TransTechnical **Bulletin**

Application: Chrysler 42/44RE
Subject: 2000-Up

Illustration A

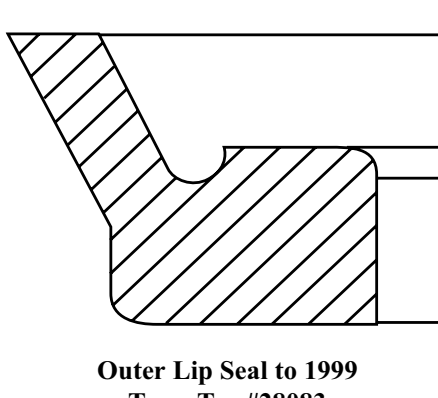
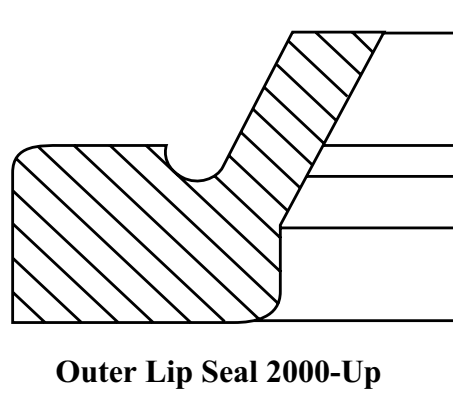
Chrysler has released a new direct clutch outer lip seal for the 42 & 44RE transmissions. The drum, piston, and outer seal have all been revised for 2000-Up models. The outer clutch piston seal is now located in the drum rather than on the piston. The inner clutch seal remains in the same place and carries the original OEM part number. TransTec #28354 (OEM #4058487AB) will be added to all TransTec kits as stock arrives, approximate date code of M00 or later.
